[Docket No. FAA-2004-18850; Directorate Identifier 2004-SW-19-AD; Amendment 39-14694; AD 2004-16-15 R1]

Airworthiness Directives; Eurocopter France Model AS-365N2, AS 365 N3, EC 155B, EC155B1, SA-365N, N1, and SA-366G1 Helicopters

ACTION: Final rule.

Figure 1

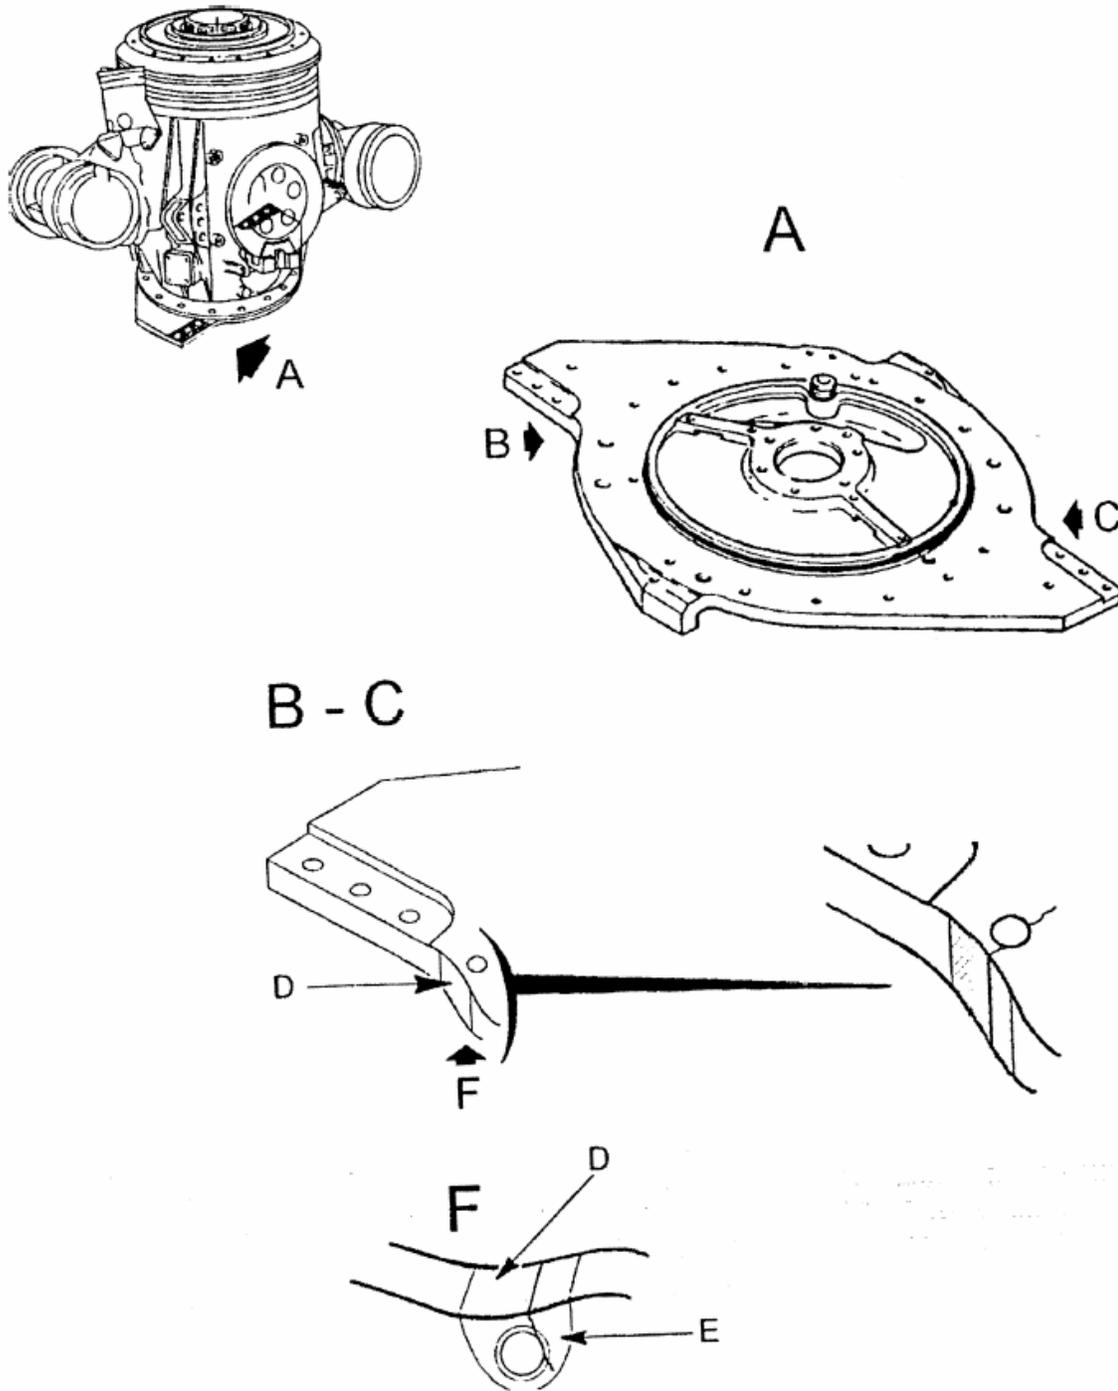
(a) Before the initial inspection at the time indicated in the compliance table of this AD, strip the paint from area "D" on both sides ("B" and "C") of the MGB base plate as depicted in Figure 1 of this AD.

(b) At the times indicated in the compliance table, inspect area "D" of the MGB base plate for a crack using a 10x or higher magnifying glass. Area "D" to be inspected is depicted in Figure 1 of this AD.

(c) If a crack is found in a MGB base plate, remove and replace the MGB with an airworthy MGB before further flight.
